IN THE MATTER of Proposed Plan Change 42 Mangaroa &
Pinehaven Flood Hazard Extents

STATEMENT OF EVIDENCE OF ROBERT HALL

Flood Hazard Map 46 Vicinity of 27 Elmslie Road, Silverstream

URBAN HAZARD MAP 46

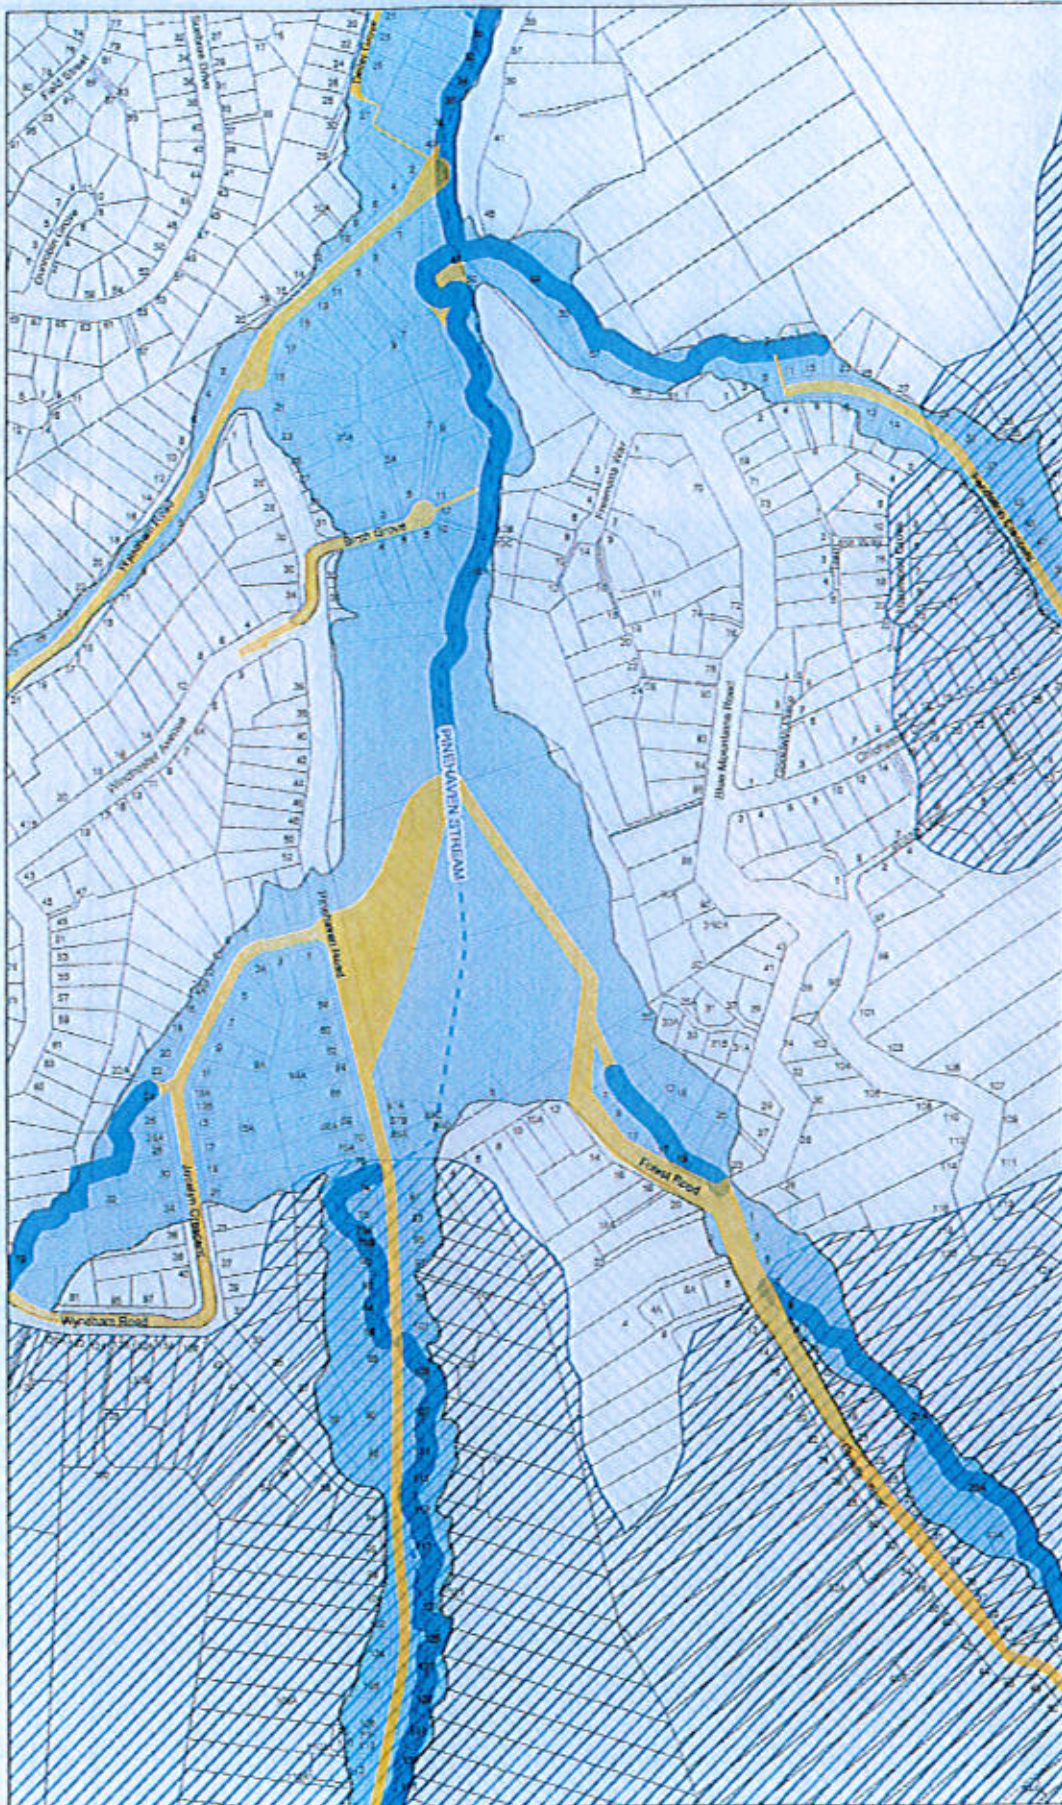
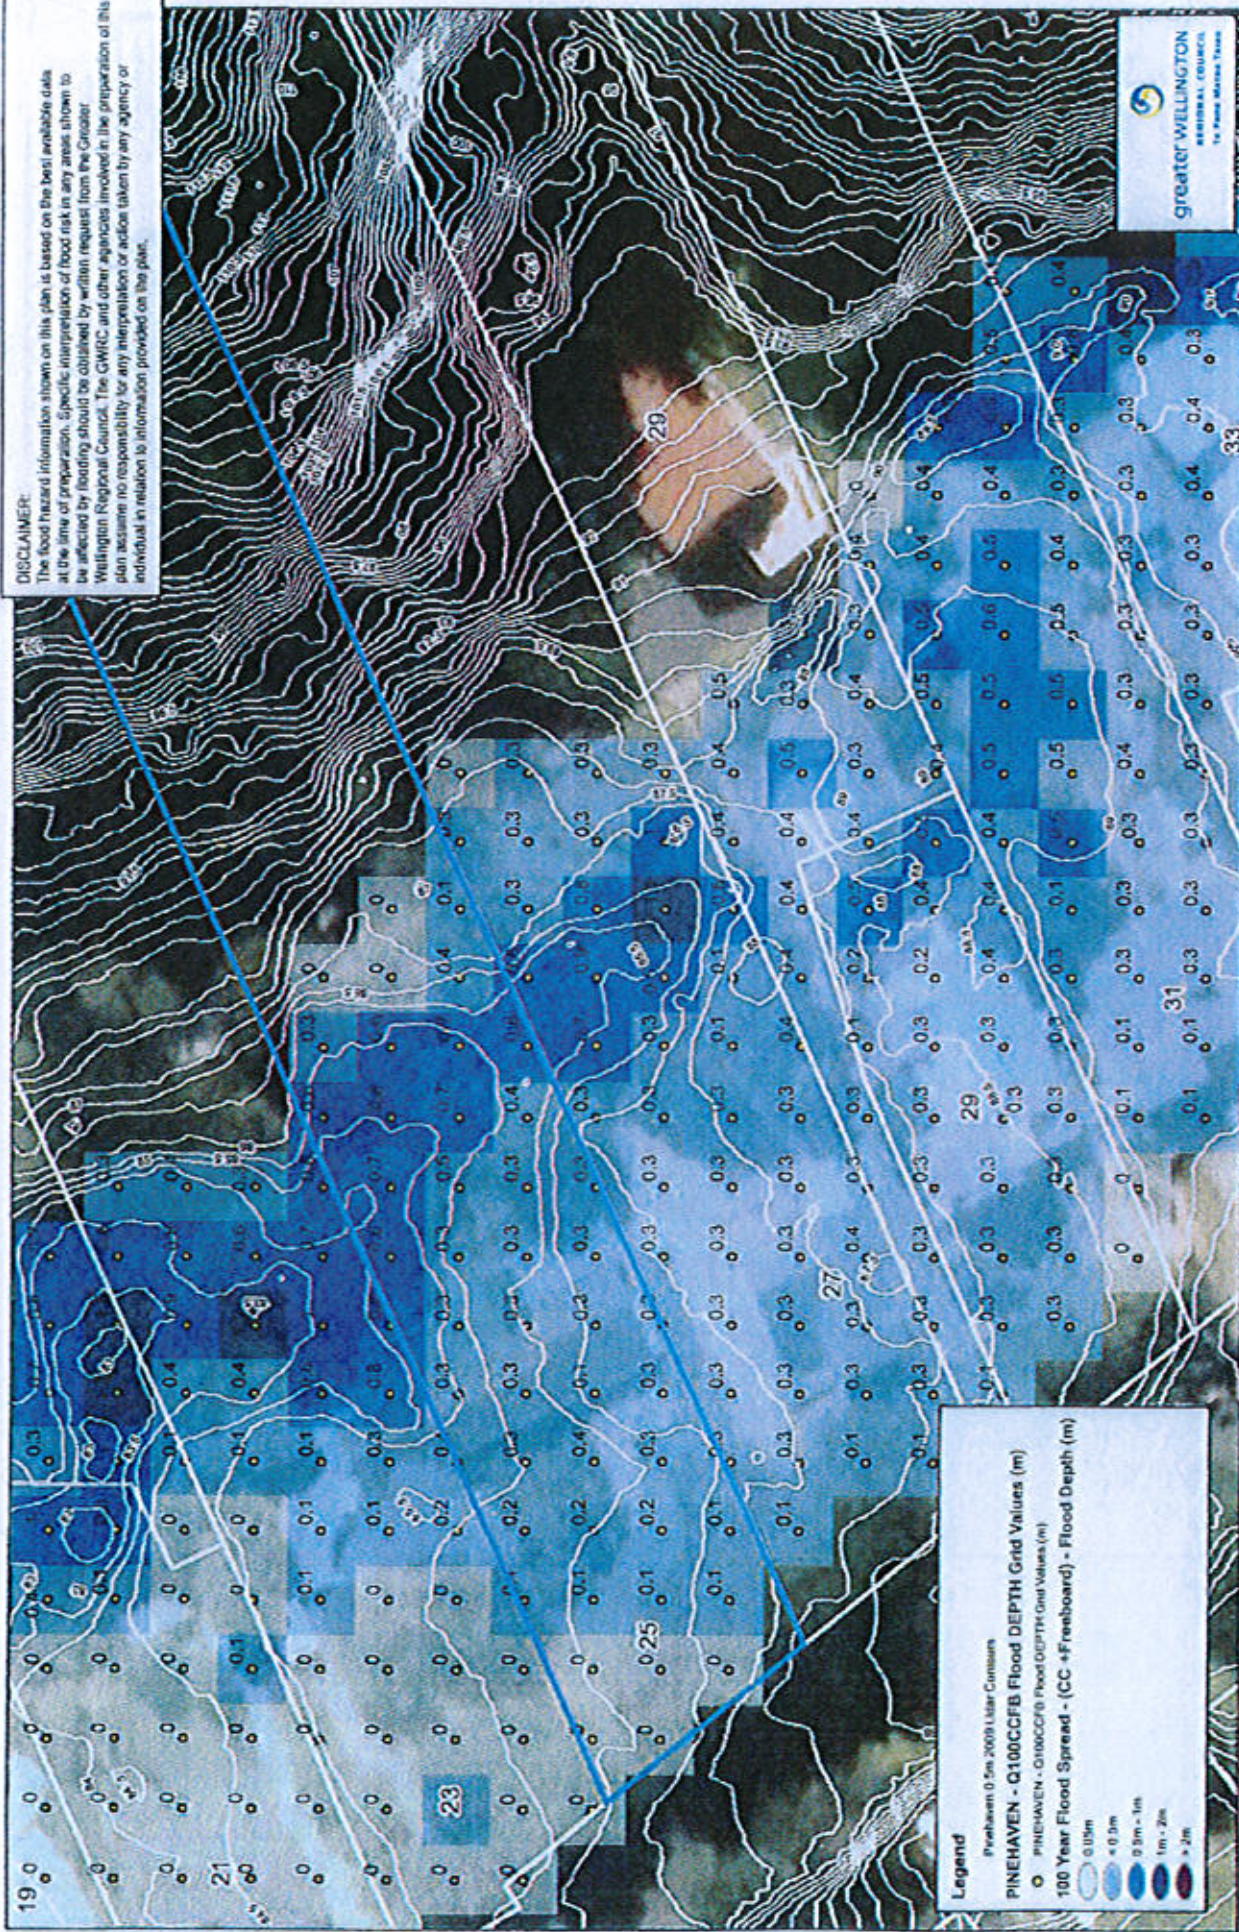
- 13 Attached Figures 1 & 2. being UHCC flood hazard map 46. Fig 1. was included in Appendix 4 of PC42 when released for public consultation. Fig 2. is the same map as Fig 1. but on which some modifications were made which affected the location of the outer limits of the " ponding areas" shown on the original Fig 1. map. As I understand it, Fig 2. was released after the consultation period closed as an appendix to the Sec 42A report for PC42 in response to a submission or submissions received through the public consultation period. I offer no opinion of the propriety or otherwise of this procedure but I note that there is nothing on

either of these maps to distinguish Fig 2 from Fig 1. other than the actual changes which were made. In my experience it is customary when preparing plans and modification are required to those plans in that process that some form of explanation and identification system is employed so that the changes which have occurred between the issues are clearly identifiable. No such system has been employed here in effect we have two plan 46's both with the same date but released at different times and with differing flood hazard zones shown on them.

- 14 The legend on Plan 46 (Fig1., & Fig2.) describe six characteristics of the plan, the extension of the "erosion hazard area", " flood hazard extent " the " ponding area", " overflow path", river / stream corridor" and " Pinehaven Catchment overlay". The underlying map shows the various parcels of land in the catchment the street names that apply and the addresses of each land parcel.

- 15 When I consider the Pattinsons property at 27 Elmslie Road, I see that most of the land on the true left of Pinehaven Stream between that stream and Elmslie Road is described as a " ponding area" in a light blue shading whilst the stream proper is defined by a darker blue shading. An overflow path is shown in yellow on Elmslie Road as an overflow path and lies beyond the south western limit of the flood hazard extent. In essence I interpret this to imply that all or most of the runoff from that part of the Pinehaven catchment rising above Elmslie road in the AEP 1 / 100 year flood is captured by that road and runs down hill more or less separately and sub-parallel to the Pinehaven Stream.

- 16 There is nothing on the plan that tells me why " ponding " as such is a flood hazard, and how that area may differ from the flood hazards that might be present in the " River / Stream corridor", nor where to find that information be it in the UHCC Mangaroa / Pinehaven flood management plans or from the GWRC. It would appear that maps such as Map 46 are intended as a first step in such a process but nowhere on either Map 46 being Fig 1. or Fig 2., is that made clear.

- (b) Flood hazard maps (e.g. Urban Hazard Map 46) contained in PC 42 needs to be made informative with the addition of text to give a clearer understanding of their purpose and where more detailed information pertaining to the flood hazards associated with the flood hazard extent on the hazard maps may be found. In order to achieve that the flood hazard maps need to show the AEP 1 in 100

- (c) The term " ponding " used on the UHCC flood hazard maps are a poor choice of terminology and should be replaced with wording which more accurately describes what the nature of the flood hazards are that are identified for such areas. Having said that the maps should ensure that they limit the areas mapped as having flood hazards present, to those areas where actual flooding and related flooding effects are likely to be present and not confuse the issue by including freeboard (s) as GWRC has done and which ultimately has been adopted by UHCC to determine what their maps describe as " flood hazard extent".

plus climate change flood profile free of freeboard and with relative flood hazard classifications clearly identifiable on those maps.

PINEHAVEN STREAM - Flood Hazard Map
 25 Elmslie Road - Water depth

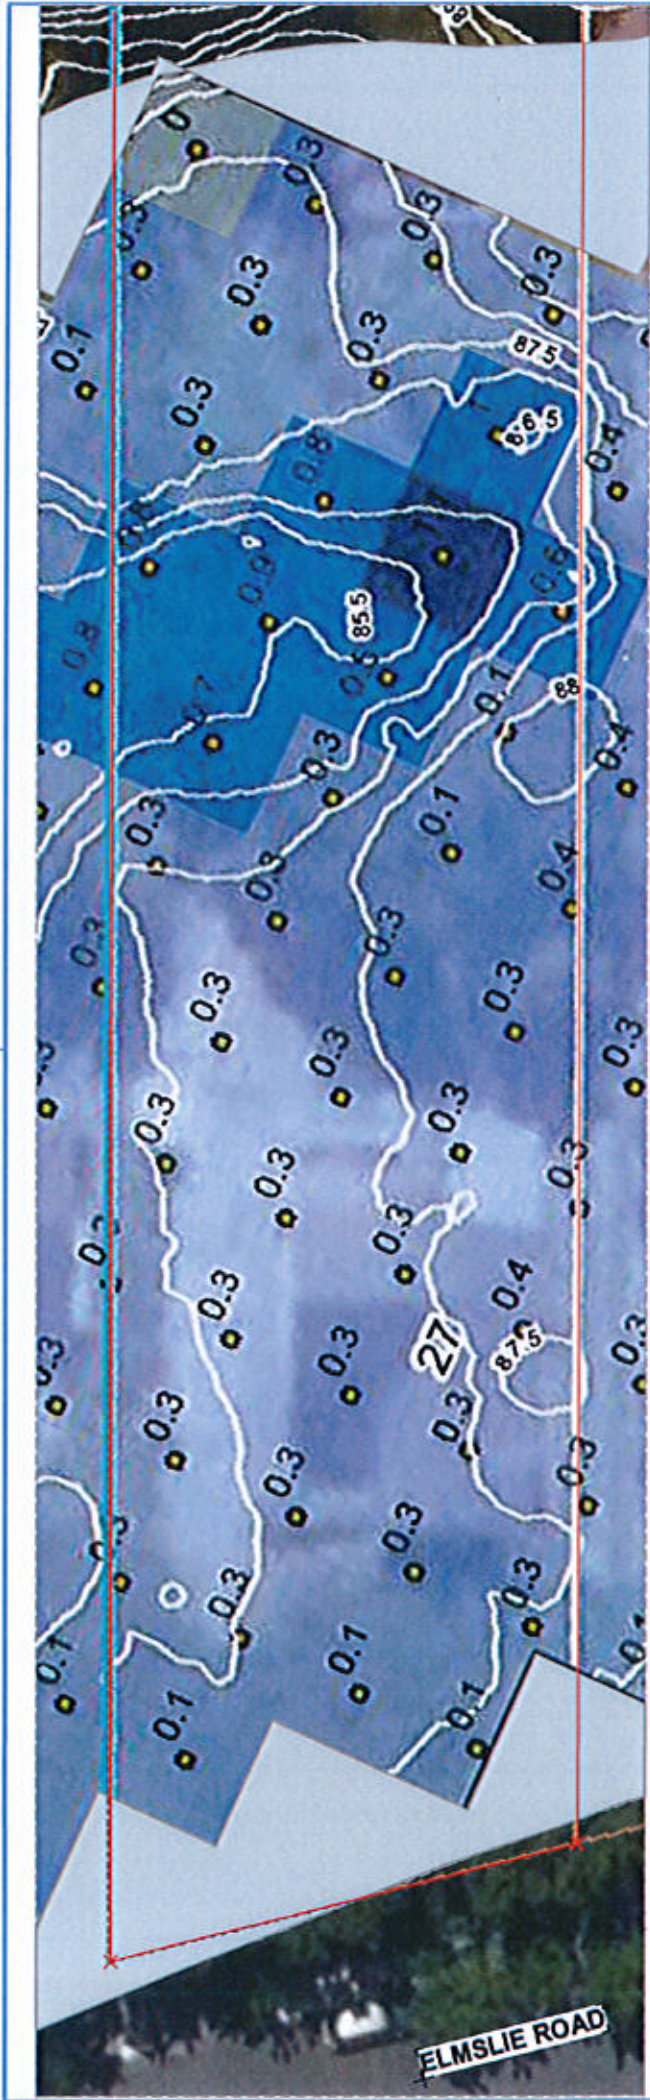
- 17 Fig's 3A & 3B. attached are Pinehaven Stream flood maps provided to a neighboring property on Elmslie Road by the GWRC at the owner of 23 – 25 Elmslie Road request in May 2017 . Fig 3A show the elevation of the flood hazard surface above ground line in metres on a grid system whilst Fig 3B gives the reduced level of that surface as opposed to the actual depth. A note on the map identifies these flood hazards as having

- 18 It is evident that these flood hazard maps extent beyond the boundary of 23 – 25 Elmslie Road and include parts of 27, 29 and 31 Elmslie Road.
- 19 The legends on Fig 3A & 3B differentiate flood hazards on the basis of depth with in particular light blue being 0.05m (i.e. presumably for depths up to 50mm), a slightly darker blue as less than 0.5m (500mm). The legend also identifies this map as representing the 100 year climate change event with freeboard and notes that the underlying 0.5m contours shown on the map are derived from a 2009 Lidar survey. These maps indicate that the Pinehaven Stream through the Pattinsons property is contained within its banks although it is difficult to determine that easily from the pixilated map format. I have carried out my own hydraulic analysis for a flow of 4.45 cumec in this reach and when my result is compared with flow depth information provided to the Pattinsons by both GWRC and M.Laws output from the GWRC hydraulic modelling it is evident that in all cases the stream flow at this level of discharge including 300 freeboard is contained with the primary channel. Fig 4 attached compares my result with the flood map produced by the GWRC for the AEP 1 / 100 flood flow with 300mm freeboard applied. There is a marked contrast in these two flood maps. This difference arises from the way the GWRC map is compiled, a 300mm freeboard is applied in both cases but their model predicts some limited shallow overland flow as well as the stream flow. When this is displayed in the manner they have used, it creates a very misleading impression of what is actually happening at the site. I will elaborate on that in Par 20 onwards. In direct contrast my map shows the actual extent of the likely flooding based on the current landform and its present use. As I will explain shortly, at present I do not think that the overland flow predicted by the GWRC hydraulic modelling will actually occur on the Pattinson property in the manner that the model predicts and accordingly the justification for mapping in the manner that they have is in my view wrong and is as a consequence creating a misleading impression of what is likely to occur in an event of this kind.

- 20 The information contained on Fig 3A. provides us with an impression of what GWRC hydraulic modelling predicts for flood depth in the AEP 1 / 100 year climate change event but it tells us nothing about the nature of the flood waters depicted on the maps other than its depth including freeboard which I understand to be 300mm although that is not stated anywhere on the map.

- 21 When I look specifically at 27 Elmslie Road on Fig 3A. the greater part of the land on the true left bank lying between Pinehaven Stream and the south western boundary of the property adjacent to Elmslie Road I see that the water depth plus 300 freeboard is with the exception of some small areas shown primarily 0.3m in depth. If there is flood water of some kind present in the areas identified with 0.3m of depth and given the intervals being used are steps of 0.1m one might conclude that the actual water depth if present at all would be in the range of 0 to 49mm assuming that the actual modelled depth excluding the 300 mm freeboard, has been either rounded up or down, in this case down. This map does not tell me what form the water has, e.g. is it "ponding" as the UHDC flood map 46 (Fig 1, Fig 2) indicate or is it moving water and if so where has that come from and what route is it following and how fast it is moving. In my experience "at a site flood hazard" is customarily determined and described on the basis of the scale of the product of the flow depth and the flow velocity. So whilst these maps are described as flood hazard maps in reality they are flood water depths maps. Having said that it is expected that the velocities associated with these depth profiles would be available from GWRC on request as it is information that is generated in the hydraulic modelling process.

23. It is fairly obvious from looking at the actual modelled water depths that can be derived from the depths shown on Fig 3A by subtracting 300mm of freeboard, that there could not possibly be 1.00 cumec of overflow on

- the land on the true left bank at 27 Elmslie Road extending up towards the road in a south westerly direction. Accordingly I conclude that A.Allan's description of the flow conditions are in fact wrong and cannot be relied upon.

28. Given the above it is difficult to see how a 300mm freeboard is necessary at all on 27 Elmslie Road in the areas on the true left bank berm area on Fig 3A where that standard has been adopted and it should be removed from both the GWRC and UHCC flood hazard map for this property from those areas.

30. Based on the assessment above I am of the opinion that for the berm area we are considering here on the true left bank of 27 Elmslie Road some clarity around the nature of the flood waters on that land in an AEP 1 / 100 year event (inc. climate change) is warranted to provide a better understanding as to what the land described on the UHCC flood hazard maps as " ponding " means because ponding per se is not accurate description of what is likely to be occurring on that land and accordingly creates a misleading impression.

PINEHAVEN STREAM - Flood Hazard Map
 25 Elmslie Road - Water level

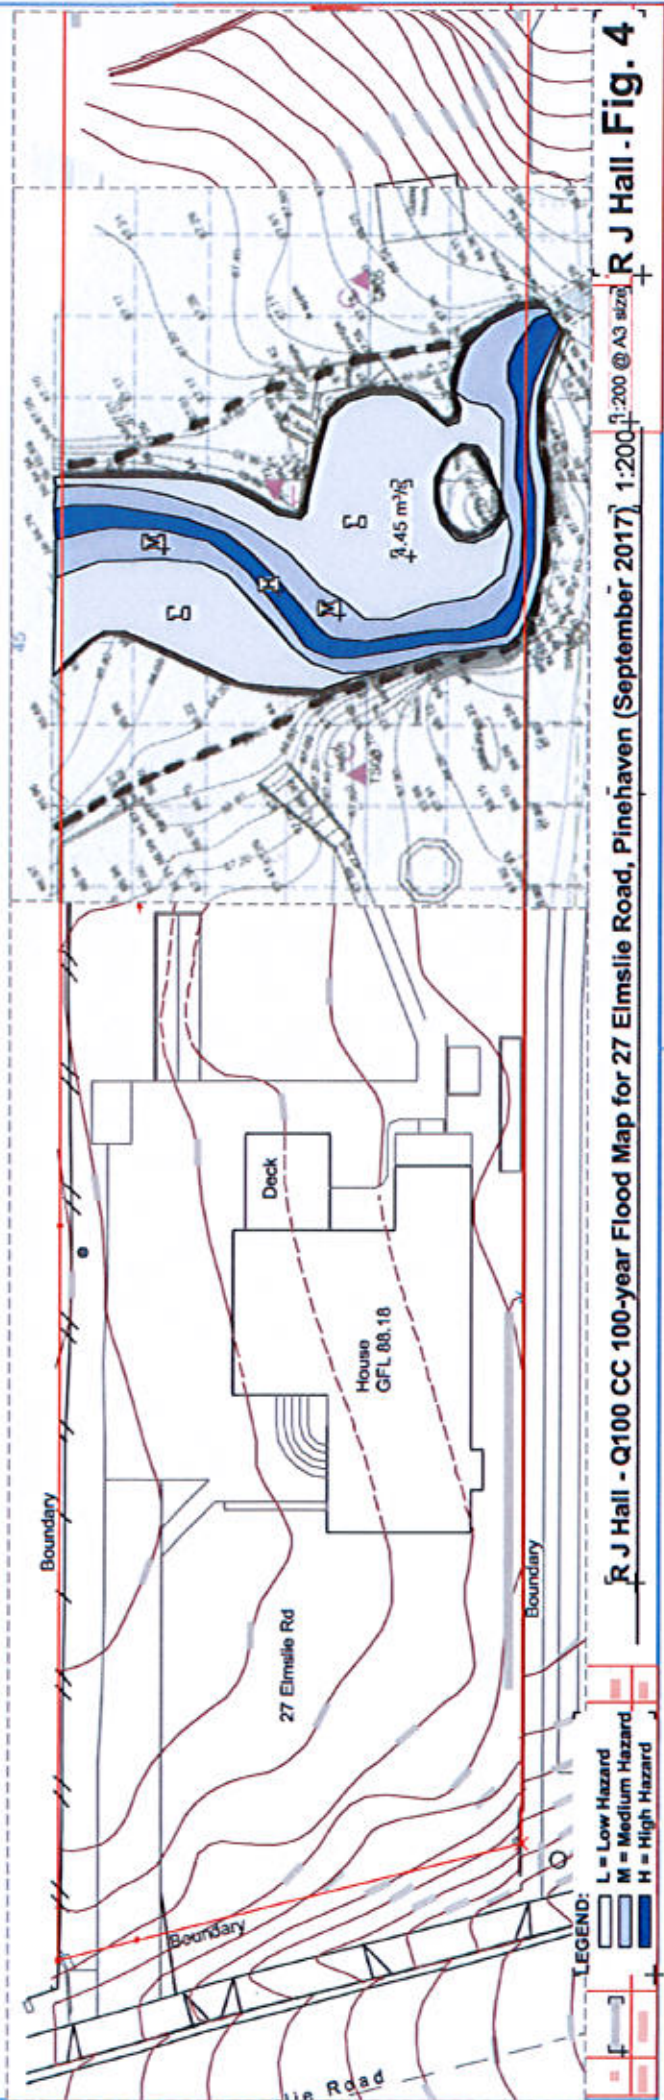
been derived for an AEP 1 / 100 year situation which includes provision for climate change and freeboard. Whilst not stated on the plans I am aware that in this part of the catchment freeboard has been set at 300mm.
